St. Joseph's Prep School, Gravesend

Response to Highway Comments (Ref. GB/20240013)

Client:	Galliard (Gravesend) Limited	Job No:	327223
Date:	21 May 2024	File Name:	240523 327223 TN 002 Rev A
Prepared by:	GB	Approved by:	JEGB

DRAWING
TITLE
REFUSE
VEHICLE TRACKING

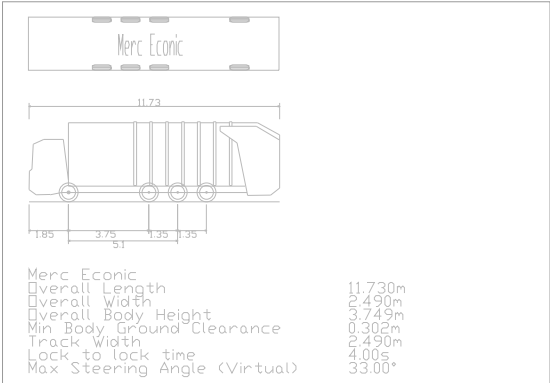
- *With the development being a cul-de-sac adequate on site turning readily able to accommodate a 12 metre refuse vehicle is required and none seems to be shown. The Kent Design Guide permits a maximum reversing distance of 20 metres for a refuse vehicle.*
- *Vehicle Turning Considerations*
 - *large service vehicles should not be expected to reverse more than 40m refuse*
 - *vehicles should not be expected to reverse more than 20m*
 - *pantechnicons should not be expected to reverse more than 60m*
 - *cars and smaller service vehicles should not be expected to reverse more than 25m.*
 - *designers should note that poor provision for parking of large vehicles will affect accesses.*

3.2.2 Tracking drawings were provided at Appendix G of the submitted TS and demonstrated that the vehicles could turn within the site at the appropriate locations. A turning head is provided at the end of the access road and is designed to reduce conspicuousness. In the GBC response, the refuse team also commented the following:

3.2.3 I am happy with the refuse collection vehicle sweep analysis which proves a turning point at the Coombe Road end of the development.
